Access Compliance Report

Public Rights-of-Way

(Curb Ramps)

Intersection ID: 10022670	Main Street: CARMENET_LN	Cross Street: N/A	Location: S
ADA ID: CA3923C7F865	Ramp Type: Perp	Initial Pass/Fail: Fail	Overall Compliance: No
Severity Score: 8.75			
Codes/Mitigation Info/Possible Solution		Field Measurements/Component Compliance

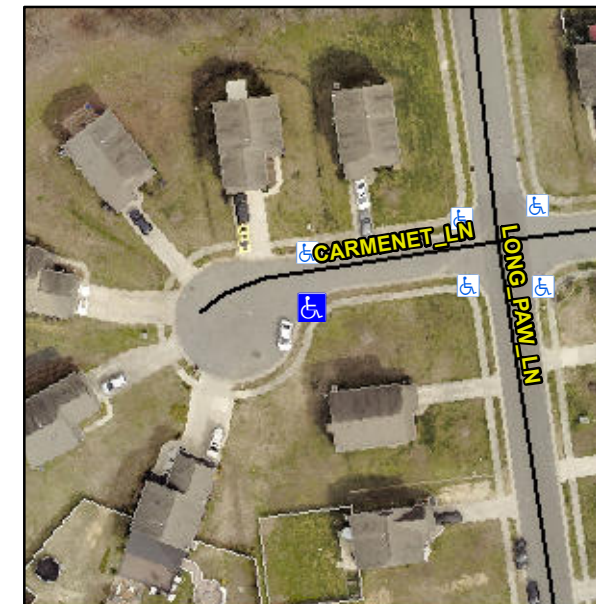
Not Found, R304.5.1

Compliance	Description	Data	Compliance	Description	Data
N/A	Ramp Length (in)	48.5	Yes	Ramp Slope (%)	7.6
No	Ramp Width (in)	41.0	Yes	Ramp XSlope (%)	1.4
N/A	Flare Type LT	N/A	N/A	Flare Type RT	N/A
N/A	Flare Slope LT (%)	N/A	N/A	Flare Slope RT (%)	N/A
N/A	Flare Traversable LT?	N/A	N/A	Flare Traversable RT?	N/A
N/A	Landing Length (in)	N/A	N/A	DWS Provided?	N/A
N/A	Landing Width (in)	N/A	N/A	DWS Contrast?	N/A
N/A	Landing Slope (%)	N/A	N/A	DWS Length (in)	N/A
N/A	Landing X Slope (%)	N/A	N/A	DWS Full Width?	N/A
N/A	Landing Curb? (Y/N)	N/A	N/A	DWS Offset (in)	N/A
N/A	Shared Landing?	N/A			
N/A	Gutter Ponding?	N/A	N/A	Gutter Slope (%)	N/A
N/A	Gutter Lip Ht (in)	N/A	N/A	Gutter X Slope (%)	N/A
N/A	Painted X Walk1?	No	N/A	Painted X Walk2?	N/A
	X Walk 1 Direction	To N		X Walk 2 Direction	N/A
N/A	X Walk 1 Width (in)	N/A	N/A	X Walk 2 Width (in)	N/A
	X Walk 1 Slope (%)	3.0		X Walk 2 Slope (%)	N/A
	X Walk 1 X Slope (%)	1.9		X Walk 2 X Slope (%)	N/A

Remove & Replace Entire Ramp.
